**Maximum power specifications
comments 478, 488, 505, 506
Mike Dudek
802.3ba Nov 11 2008**

Figure 52-8—Transmitter eye mask definition

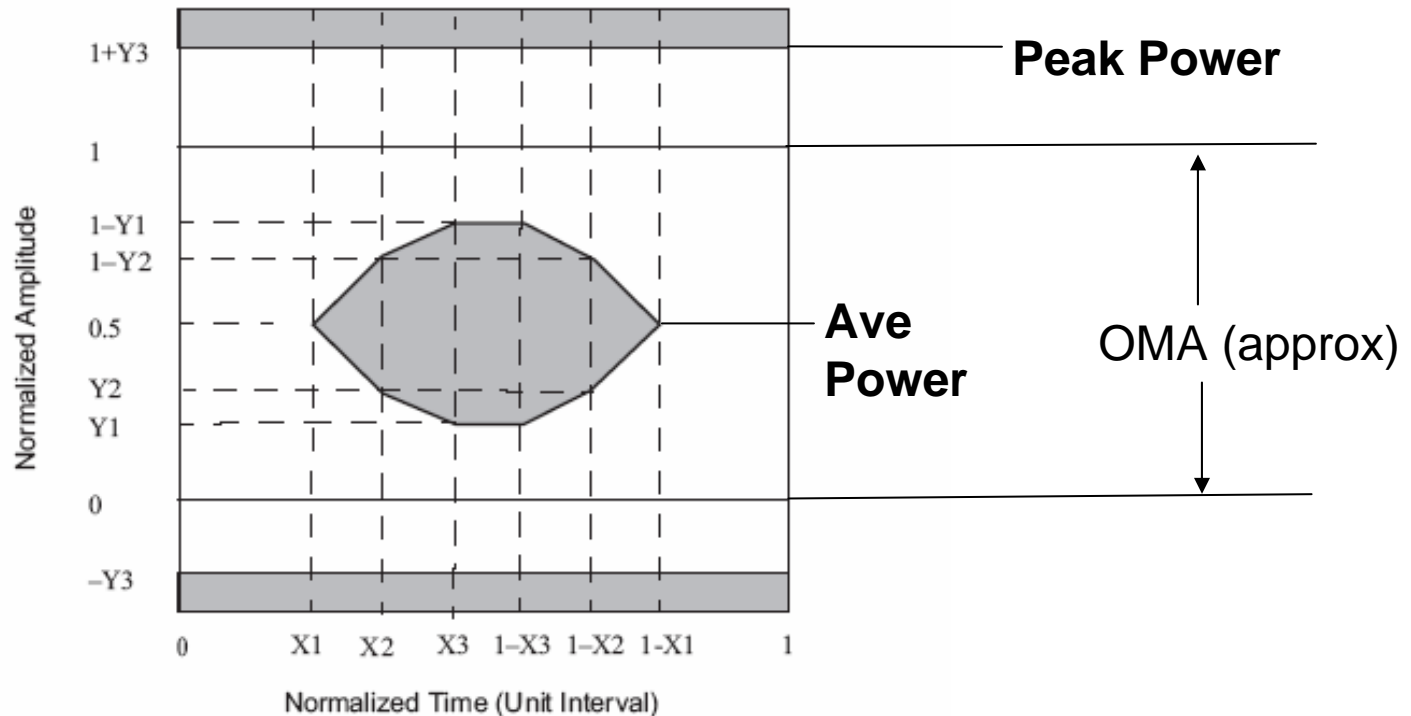
Calculation for Peak power based on max average power and max OMA.

- **Peak power (mw) = Average Power (mW)+(0.5+Y3)OMA(mW)**

Situation for 100GBASE-LR4

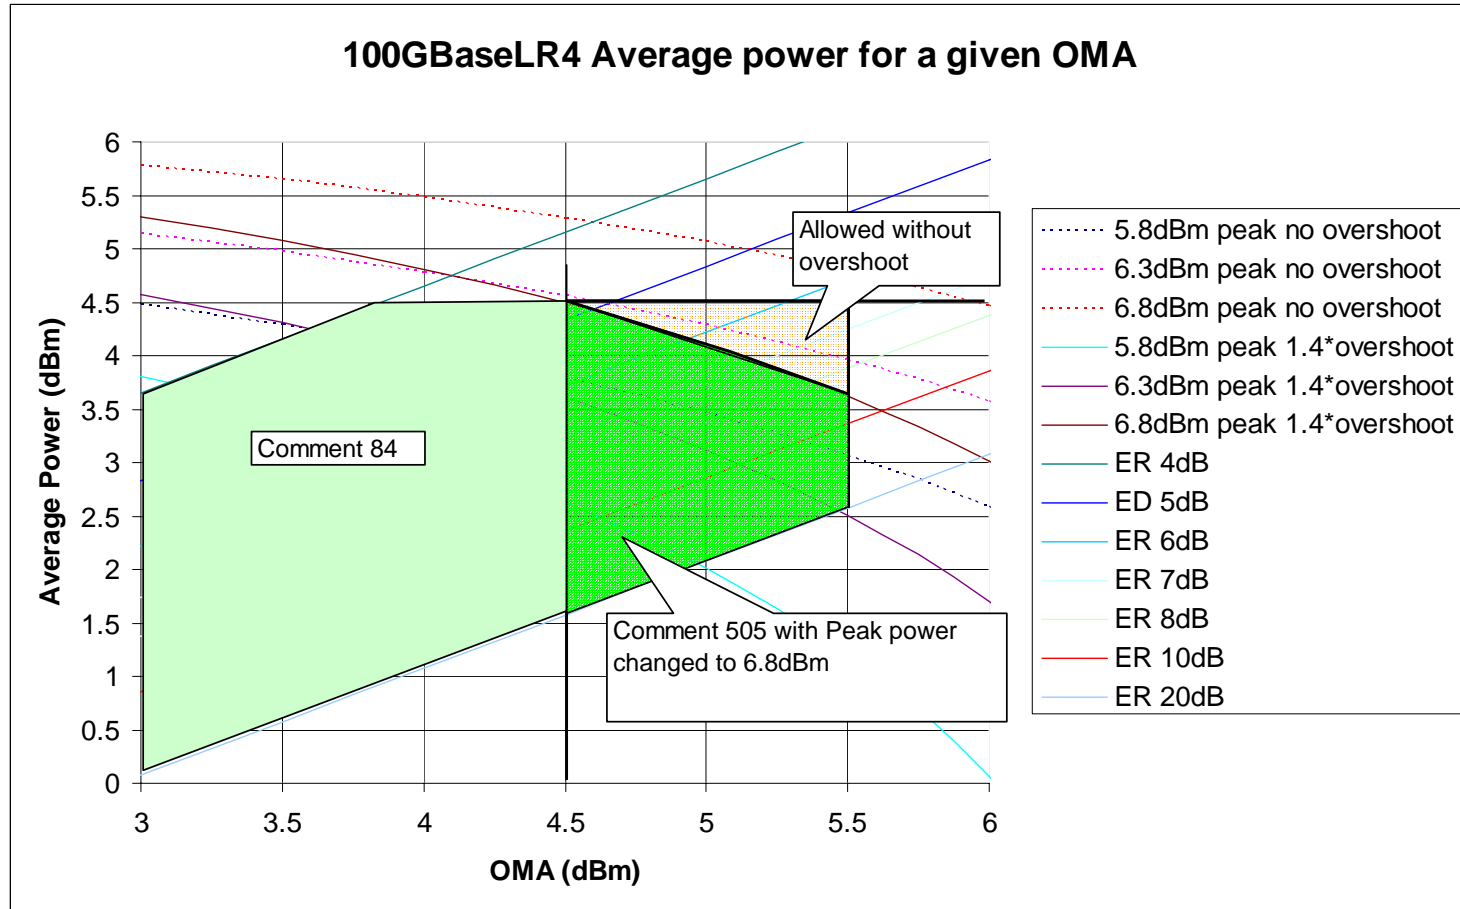
- Max average power 4.0dBm
- Max OMA 4.0dBm
- Eye mask TBD
- Assume eye mask from 10GBASE LR ($Y_3=0.4$) gives peak that Rx must tolerate of 6.8dBm.

■ Comment 84 changes to

- Max average power 4.5dBm
- Max OMA 4.5dBm.
- Assuming $Y_3=0.4$ gives peak that Rx must tolerate of 7.3dBm.

- Comment 505 suggested adding peak power spec of 6.3dBm and relaxing max OMA to 5.5dBm. On further reflection a peak power spec of 6.8dBm with the same relaxation to 5.5dBm max OMA seems better.

Comment 505 for 100GBaseLR4 with peak power changed to 6.8dBm
